DCP/NRC0975
NSD-NRC-97-5257
Docket No.: 52-003

SUBJECT: HYDROGEN CONTROL MEETING ACTION ITEMS

May 20, 1997 Hydrogen Meeting Action Items

Figure 6A-1

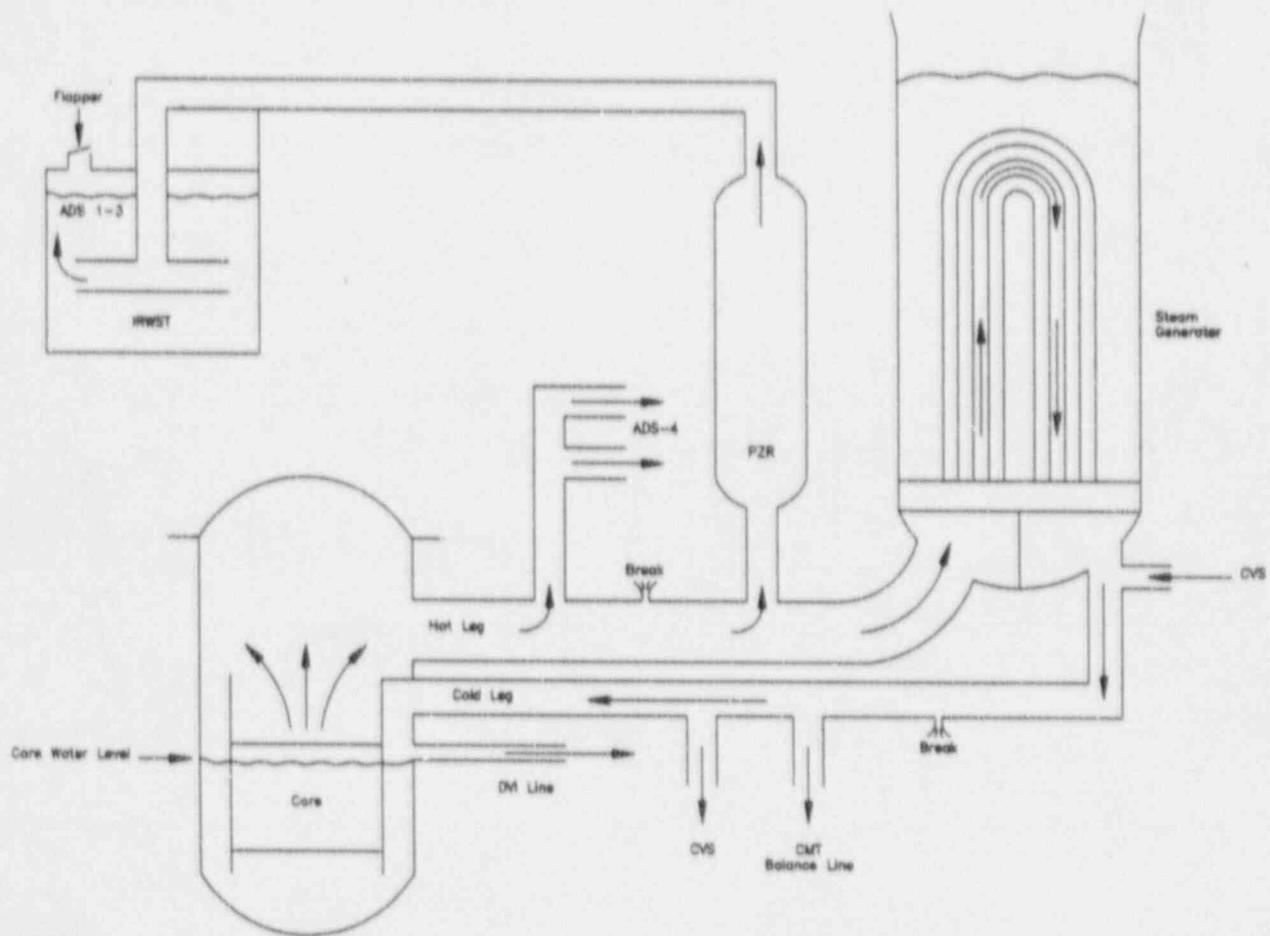
- I.A.2 Westinghouse will incorporate the substance of the February 7, 1997 letter (DCP/NRC0735) (5369) on aerosol mixing into SSAR Subsection 6.2.4. The discussion will be supplemented for treatment of downward flow, condensation in dome, and the scope will be changed to include hydrogen and aerosol mixing in the long term.

Information on the distribution of hydrogen in containment is being added as Appendix 6A of the SSAR.

Stage 4 automatic depressurization system lines relieve reactor coolant system coolant, steam, and fission products from the hot legs (see Figure 6A-1) to the steam generator compartments above the maximum water flood-up level. The stage 4 lines consist of four 10-inch schedule 160 lines. Two lines are connected to each of the two hot legs. Each of these trains relieves at the 112-foot elevation to a steam generator compartment.
